CONTRACT CHANGE ORDER No. 170
 SHEET _____ OF _____

ROADWAY LEVEL EASTBOUND LIGHTING AND ELECTRICAL SYSTEMS

EE-48

ROADWAY LIGHTING POLE LOCATION PLAN-SHEET 48 SKYWAY STRUCTURES

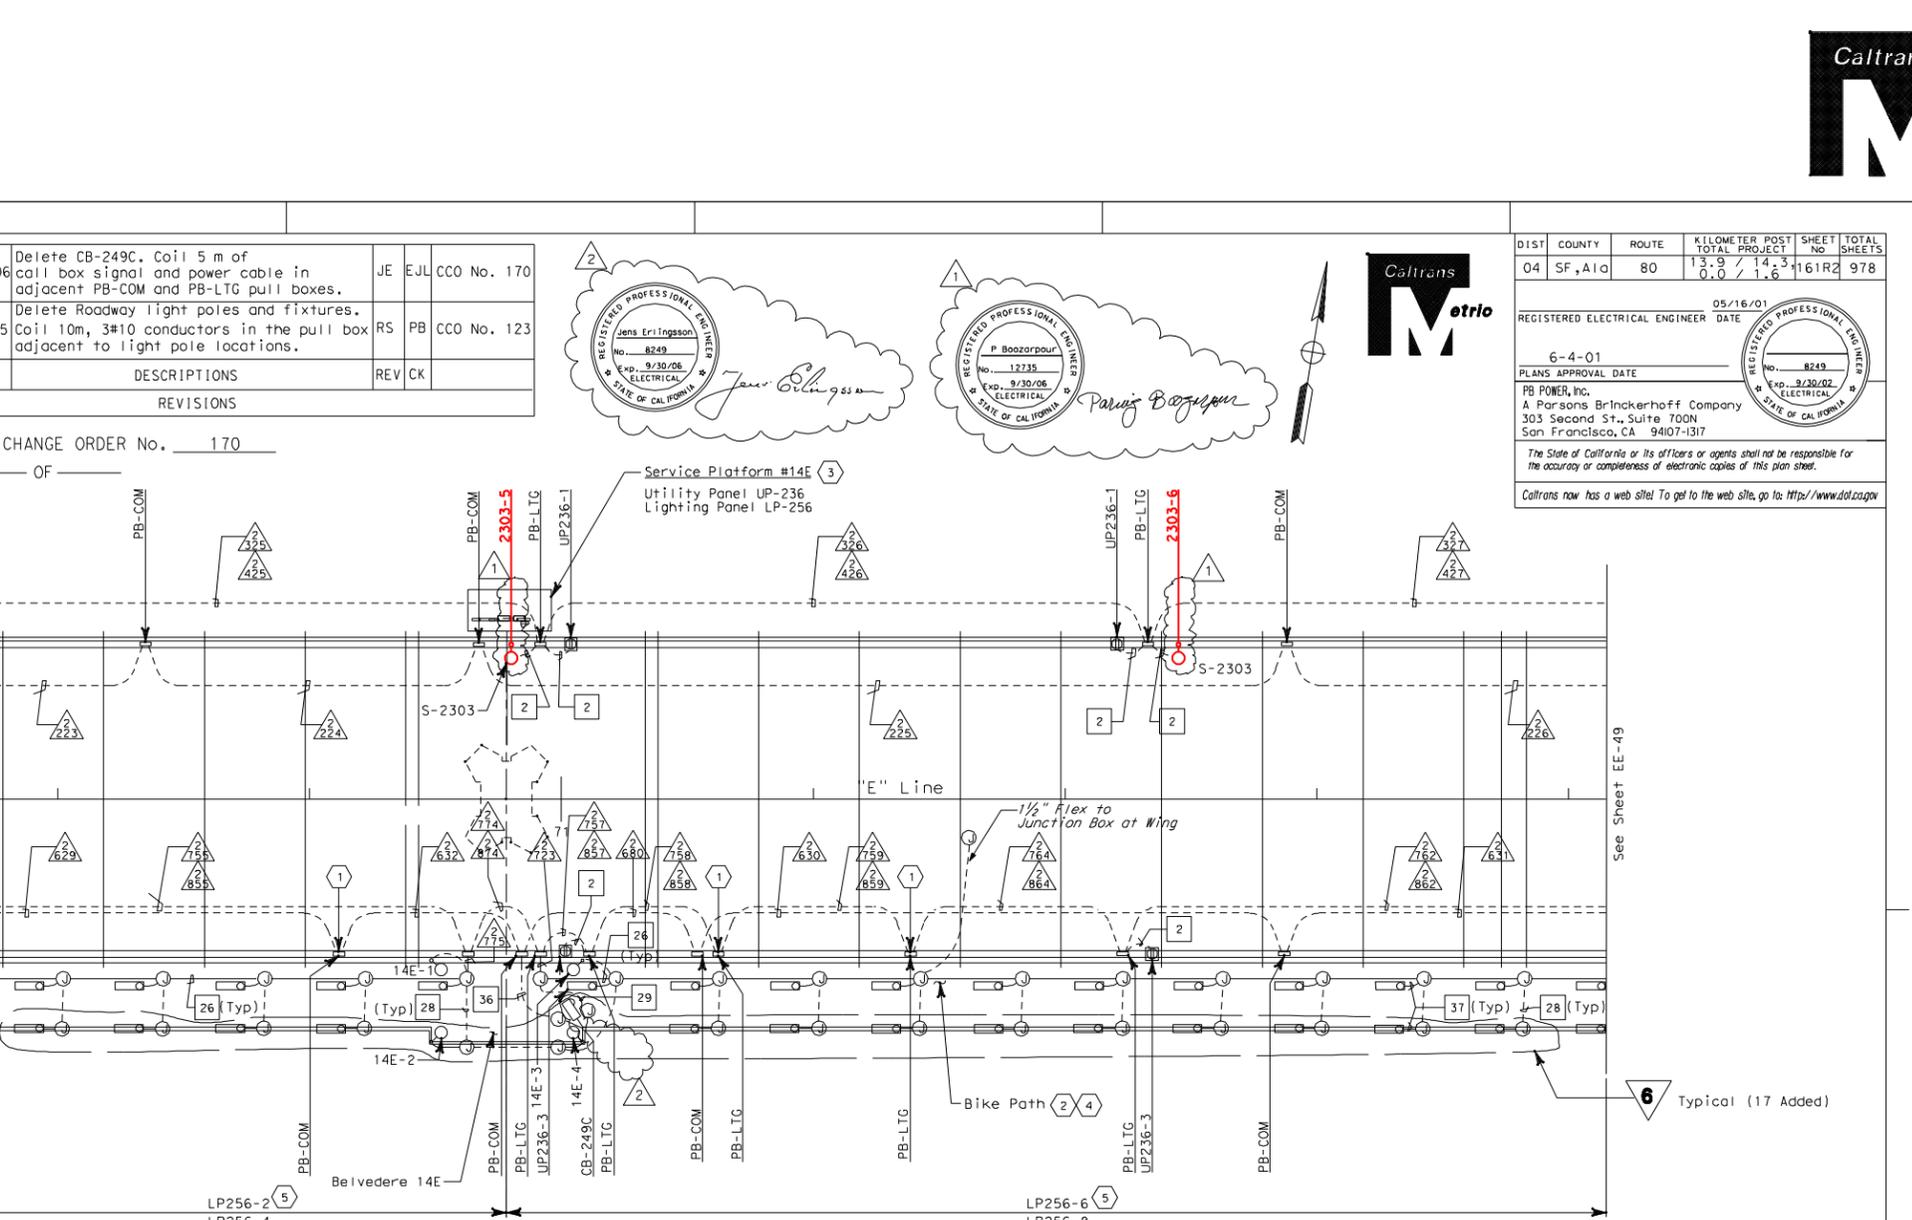
MARK	DATE	DESCRIPTIONS	REV	CK
2	1/20/06	Delete CB-249C. Coil 5 m of call box signal and power cable in adjacent PB-COM and PB-LTG pull boxes.	JE	EJL
1	3/2/05	Delete Roadway light poles and fixtures. Coil 10m, 3#10 conductors in the pull box adjacent to light pole locations.	RS	PB
